BELL SYSTEM PRACTICES
Station Installation and Maintenance

ADDENDUM C44.213
Issue 1, April, 1956
AT&T Co Standard

TELEPHONE BOOTH

KS-14611, LIST 2

Fig. 10—Shipping Skid

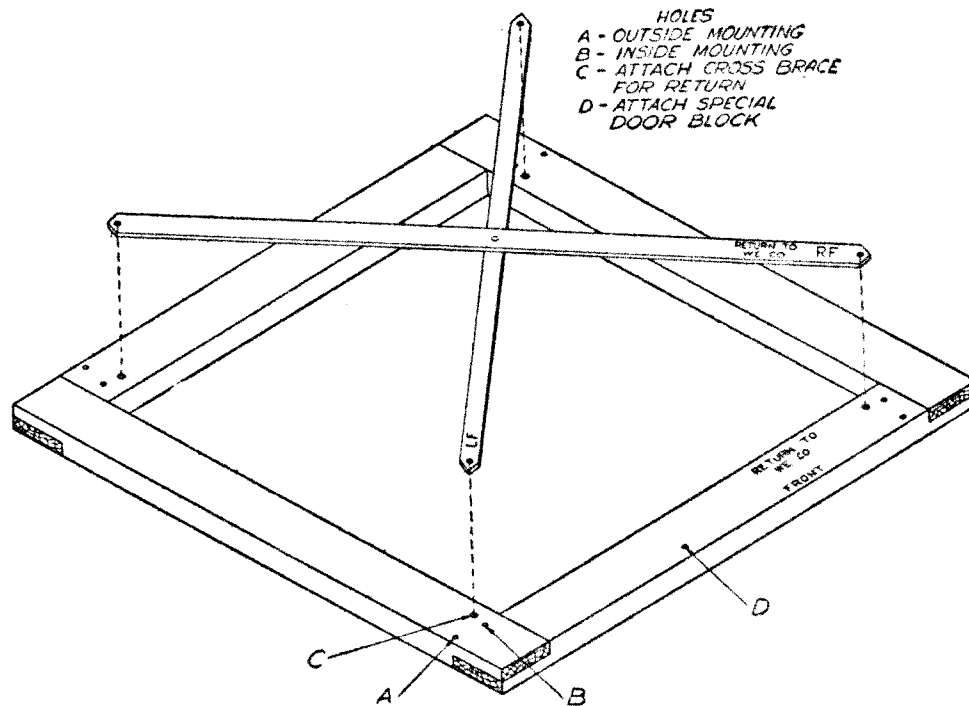
Fig. 10 replaces Fig. 2.

4.04 Change to read: The KS-14611, List 2 booth **shall not be moved without the skid and cross brace being in place.**

The door should also be secured with a door block when furnished. Two types of door blocks are being used, the P-40116 block which fastens in the door track and secures the door in the open position, and a special door block which fastens to the shipping skid and secures the door in the closed position. If a door block is not provided, secure several wraps of friction tape, or its equivalent, around the center of the folded door, using the directory rack as an anchorage. After the booth is in place, the skid, cross brace, and door block are to be returned to the Western Electric Company. Bolt the cross brace to the top surface of the shipping skid with cross brace shipping bolts, in the same position that it occupies in shipment of the booth from the distributing house, thread the booth hold-down bolts into the inside mounting holes, and bolt the special door block to the shipping skid. The P-40116 block can readily be attached to any of the protected inside vertical surfaces of the skid.
